Reindeer Project Construction Services, Savoonga
EDA Project Number 07 79 07873

Addendum #1

06/24/2024

Summary of items included in this addendum:

A-601

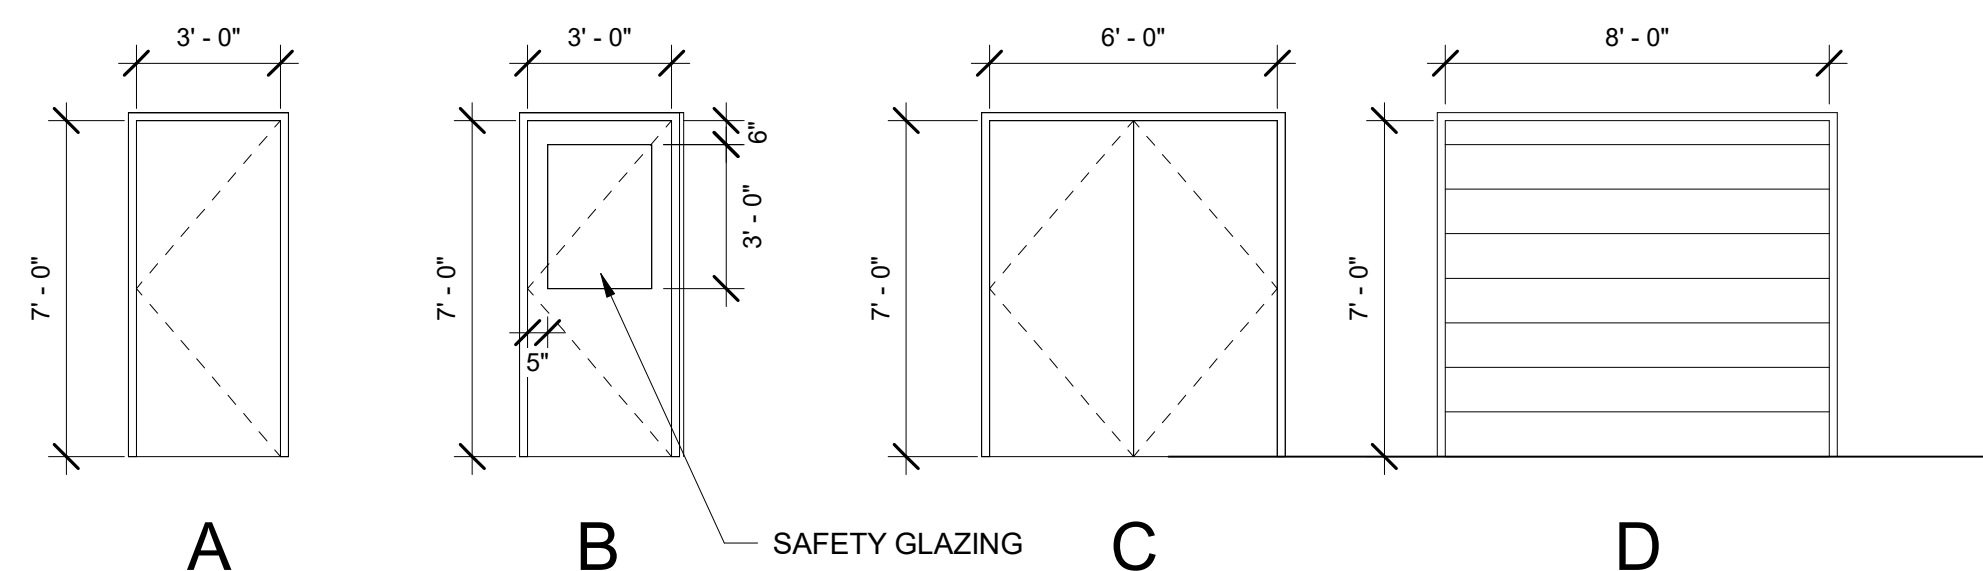
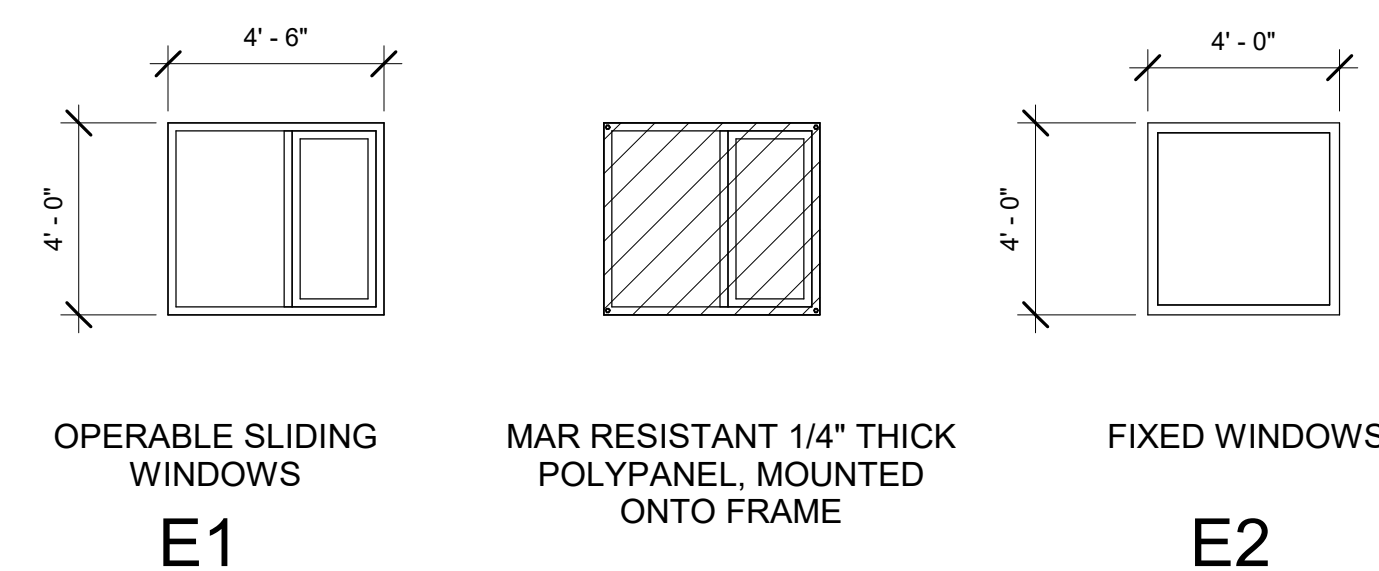
1. Pre-bid meeting agenda / notes, attendee list and site photos
 - pg. 2 – 11
2. List of questions received during solicitation period and answers
 - pg. 12
3. Specification Section 00 41 13 (Bid Form – Stipulated Sum (Single-Prime Contract)) has been revised.
 - pg. 13 - 16
4. Sheet A-601 has been revised to include clarifications to the room finish schedule and finish schedule abbreviations.
 - pg. 17
5. Sheet C-200 has been revised to clarify responsibility of utilidor construction.
 - pg. 18

8. On the Room Finish Schedule on A-601, please confirm that FRP panels are to be installed for the flooring in the bathroom.
9. Are there any liquidated damages if the project is not finished at the final completion date? And if so, how much?

<u>Question Number</u>	<u>Question</u>	<u>Response</u>
1	Will you be issuing a schedule for section 087100 on this project?	Yes, the door and frame schedule is on sheet A601. Sheet A-601 has been revised to include clarifications to the room finish schedule and finish schedule abbreviations. The revised A-601 sheet is included in addendum #1.
2	Okay so what I did not see to be able to quote properly is the Hardware schedule for the doors and frames and if you will not have one then I would need the general idea below:	The hardware schedule is in the spec and should address your questions. Refer to Spec section 08 71 10 paragraph 3.8.
3	The bid document asks for a subcontractor in section 004113 - 2 for masonry work however, there is no work under this scope. Therefore, what masonry work is anticipated for this project?	Masonry work is not required as part of this project. Spec Section 00 41 13 has been updated and is included as part of addendum #1.

C-200

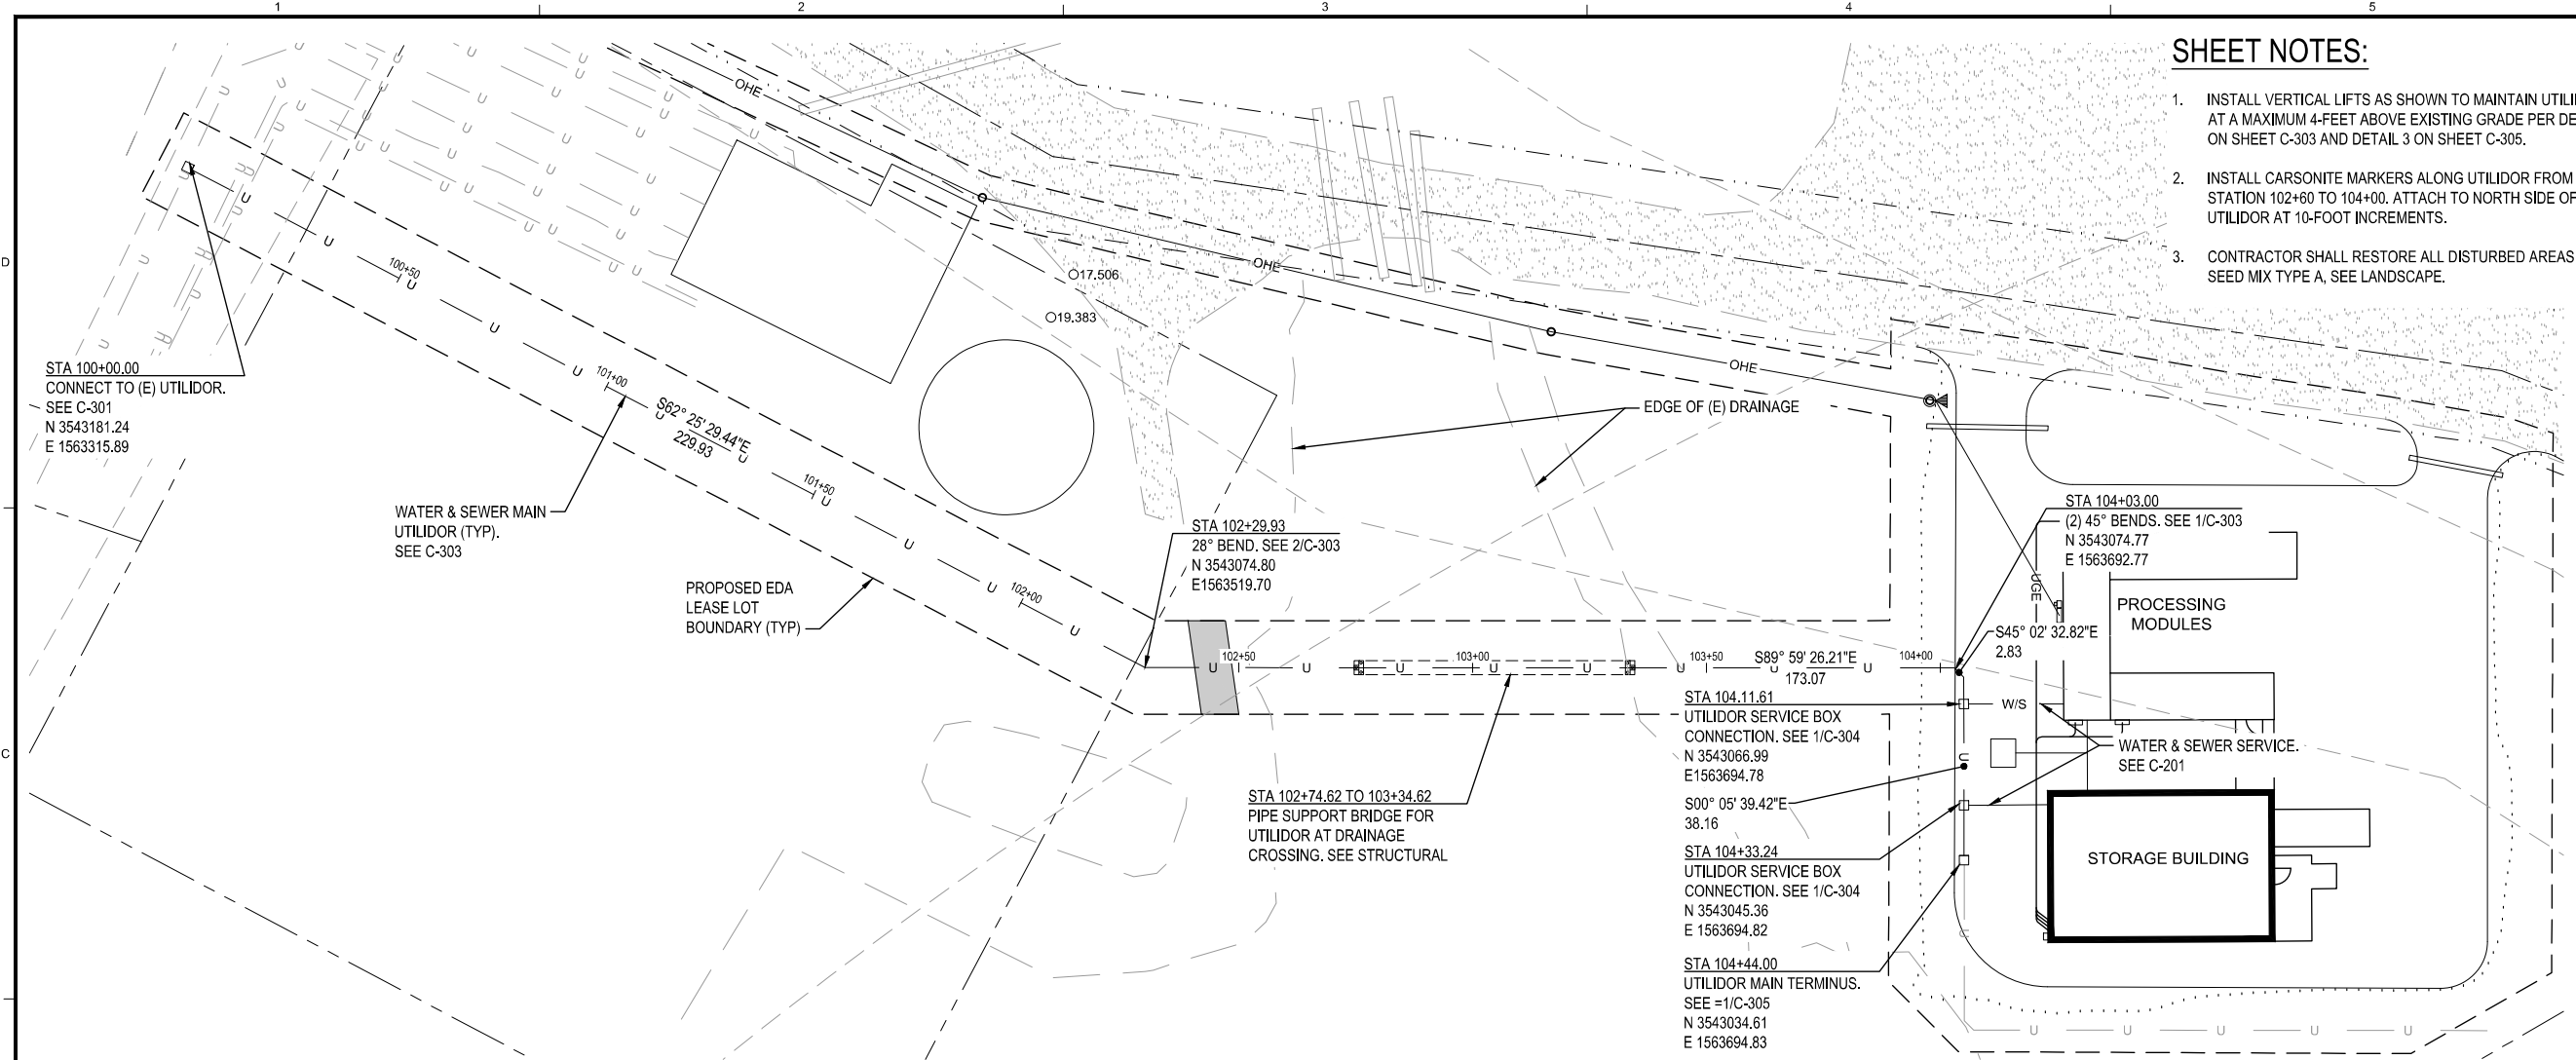
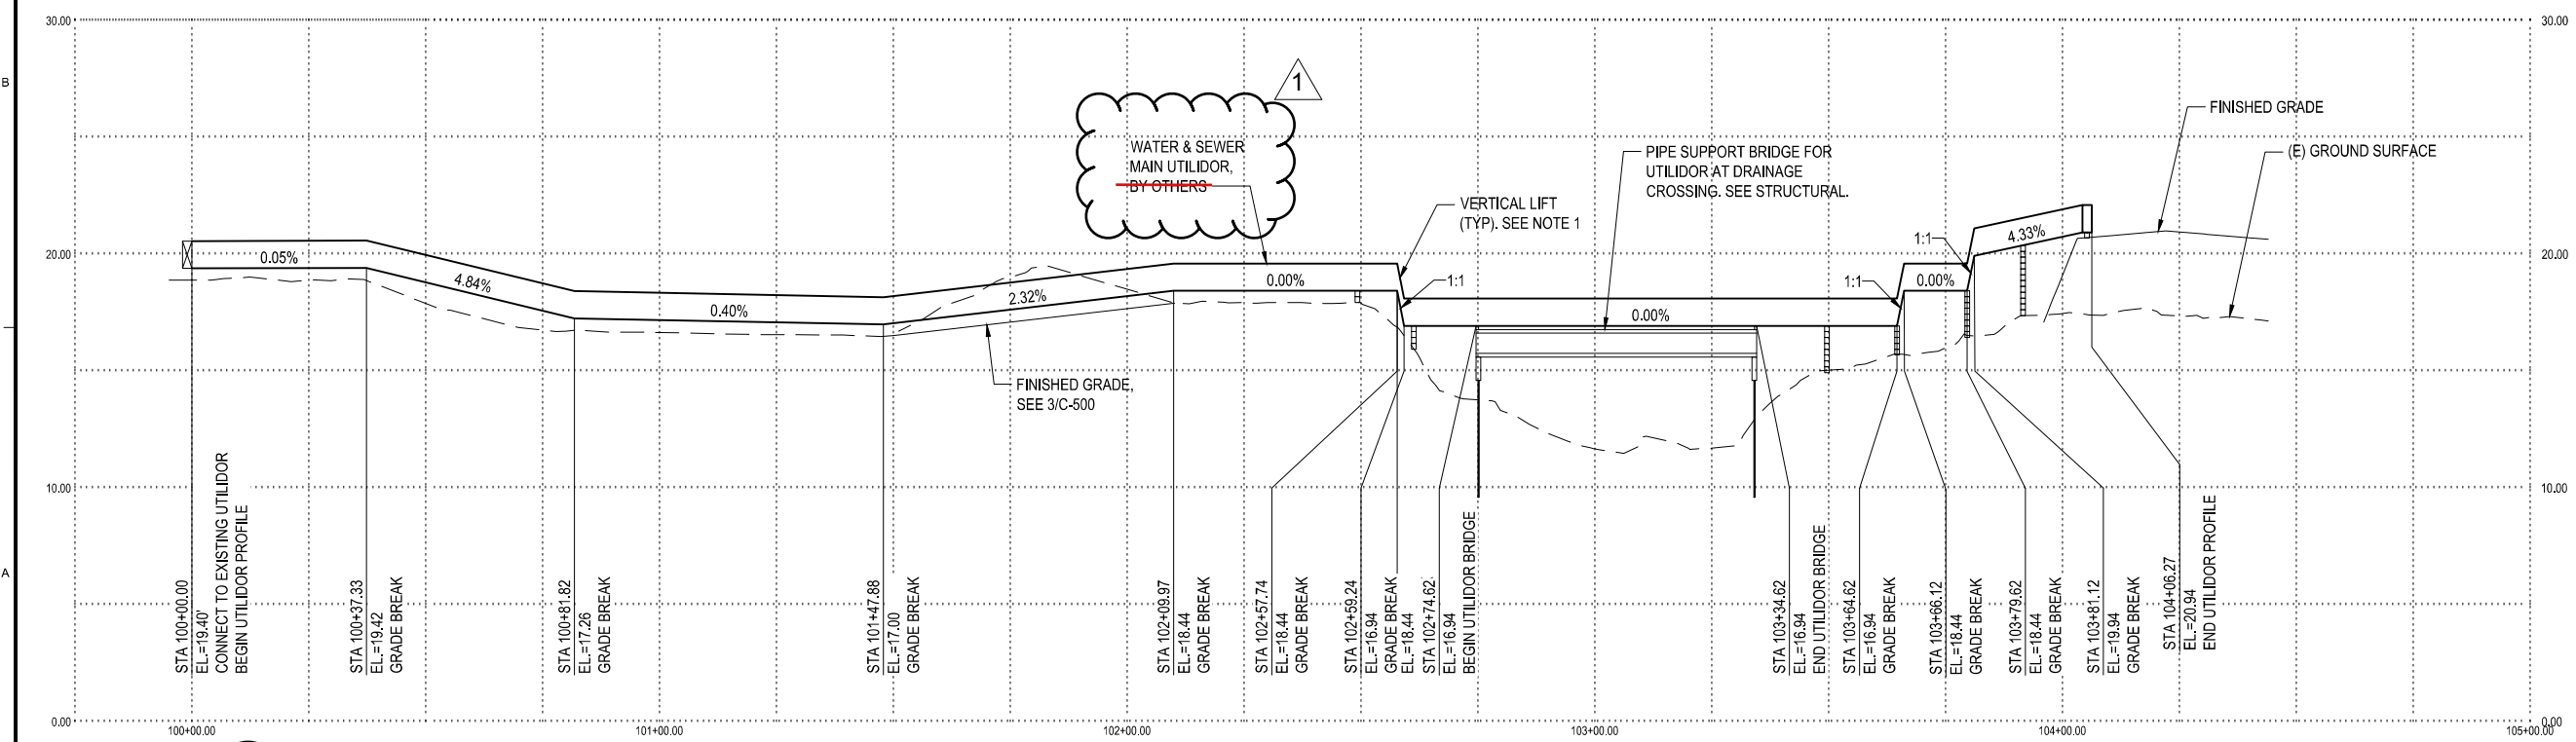
6. Please provide modular connection details. (Structural, roofing and siding details)
7. Please confirm if the Water & Sewer Mains utilidor will be supplied and installed by others. See sheet C-200, detail 2

6	Please provide modular connection details. (Structural, roofing and siding details)	Pending
7	Please confirm if the Water & Sewer Mains utilidor will be supplied and installed by others. See sheet C-200, detail 2	All water and sewer main utilidors shall be furnished and installed by the general contractor. C-200 has been updated to remove "by others" and is included in addendum #1.
8	On the Room Finish Schedule on A-601, please confirm that FRP panels are to be installed for the flooring in the bathroom.	Sheet A-601 has been revised to include clarifications to the room finish schedule and finish schedule abbreviations. The revised A-601 sheet is included in addendum #1.
9	Are there any liquidated damages if the project is not finished at the final completion date? And if so, how much?	The only liquidated damages required in the contract by the Economic Development Administration requirements are those referenced under the Labor Standards – Contract Work Hours and Safety Standards Act for not paying a laborer or mechanic appropriately for overtime per Section 16 of the EDA Contracting Provisions for Construction Projects.

- INSTALL VERTICAL LIFTS AS SHOWN TO MAINTAIN UTILIDOR AT A MAXIMUM 4-FOOT ABOVE EXISTING GRADE PER DETAIL 3 ON SHEET C-303 AND DETAIL 3 ON SHEET C-305.
- INSTALL CARSONITE MARKERS ALONG UTILIDOR FROM STATION 102+60 TO 104+00. ATTACH TO NORTH SIDE OF UTILIDOR AT 10-FOOT INCREMENTS.
- CONTRACTOR SHALL RESTORE ALL DISTURBED AREAS WITH SEED MIX TYPE A. SEE LANDSCAPE.
